To: Gary Wert
From: Jeff Walton, Associate Planner; 910-341-3260
CC: File;
Date: 6/23/2016
Re: Ogden Marketplace Planning Comments (Landscape revisions)

Landscape Plan:

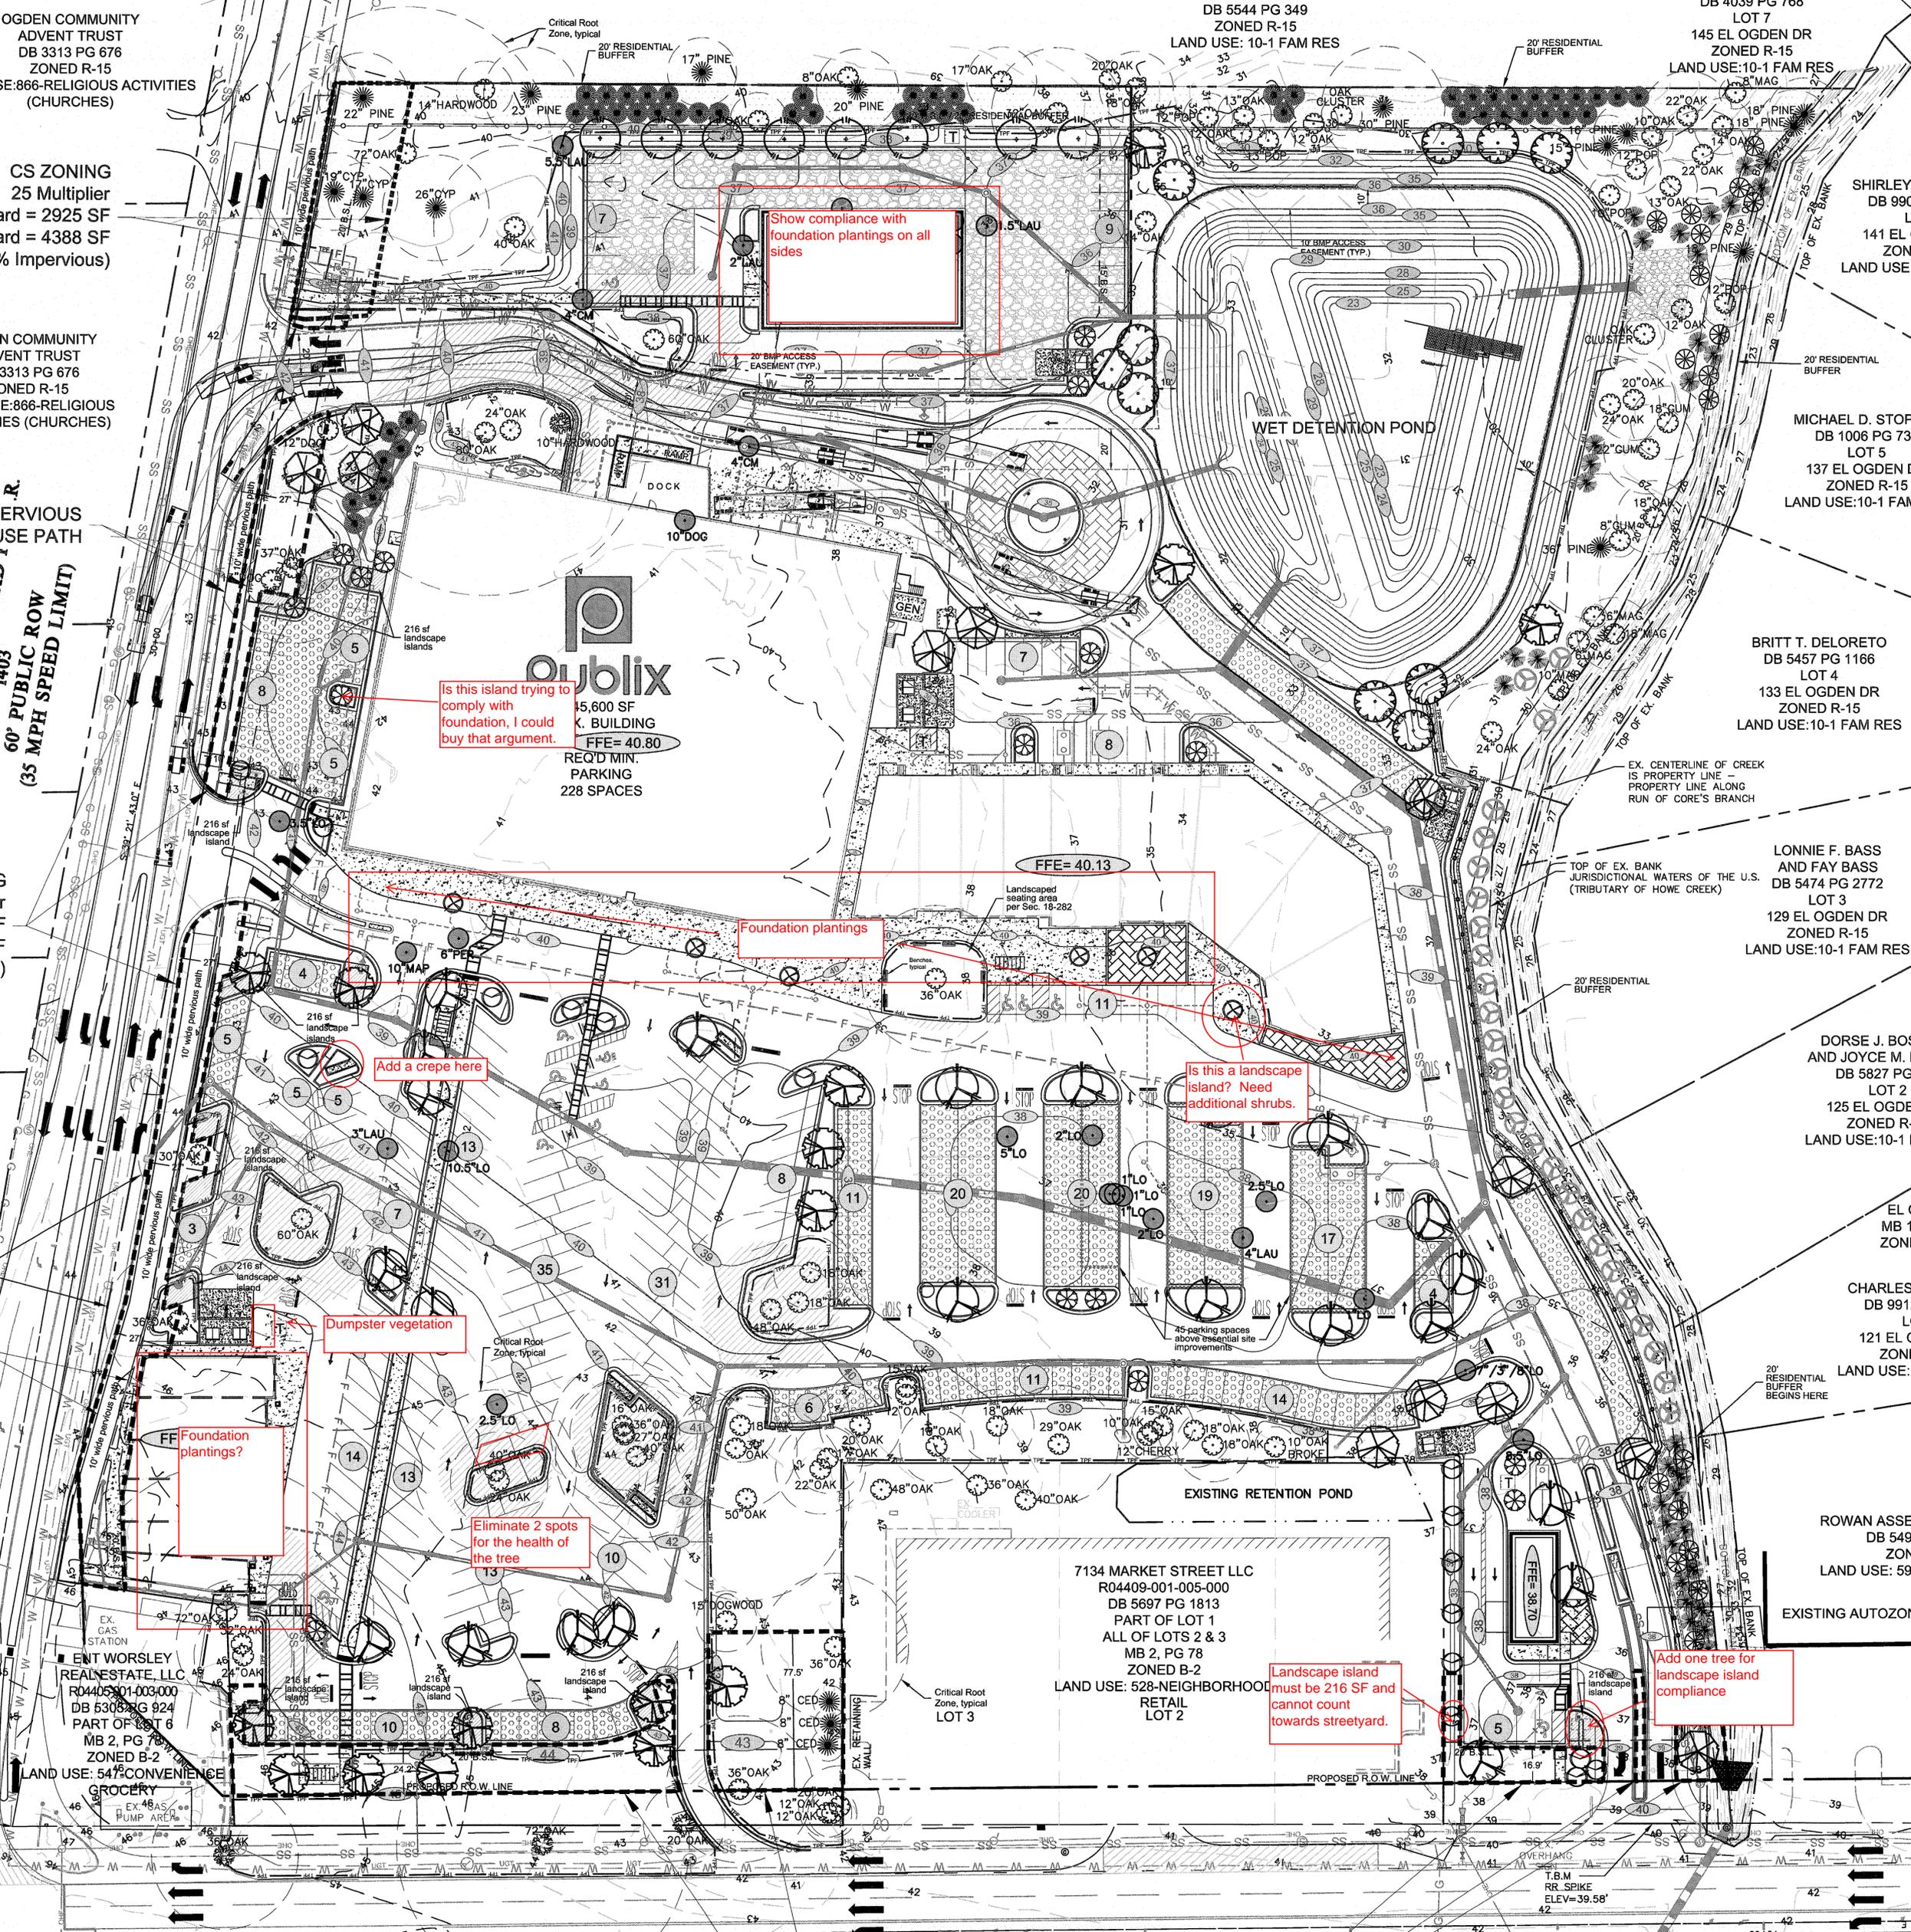
- There has been a discussion of the need or removal of the desire to spade trees. If this is decided not to pursue, I need the mitigation and credits updated on the plan sheet.

- I need a few additional trees added in landscape islands for compliance, and I attempted to redline them.
- The legend will need to be tweaked for your planting schedule. Can you separate into four categories: 1. Large Shade Tree 2. Small Shade tree 3. Shrubs 4. Groundcovers.

- Sec. 18-462 (d) (4): Show note on plan stating that prior to any clearing, grading, or construction activity, tree protection fencing will be installed around protected trees or groves of trees. And no construction workers, tools, materials or vehicles are permitted within the tree protection fencing.

- I didn't see this note, but I may have missed it, just let me know the page number.
- Sec. 18-462 (d) (6): Show details of required landscaping showing species, dimensions, and spacing of planted materials and the use and protection of existing vegetation.

Show compliance with
foundation plantings on all
sides

Is this island trying to
comply with
foundation, I could
buy that argument.

Add a crepe here

Is this a landscape
island? Need
additional shrubs.

Dumpster vegetation

Foundation
plantings?

Eliminate 2 spots
for the health of
the tree

Landscape island
must be 216 SF and
cannot count
towards streetyard.

Add one tree for
landscape island
compliance
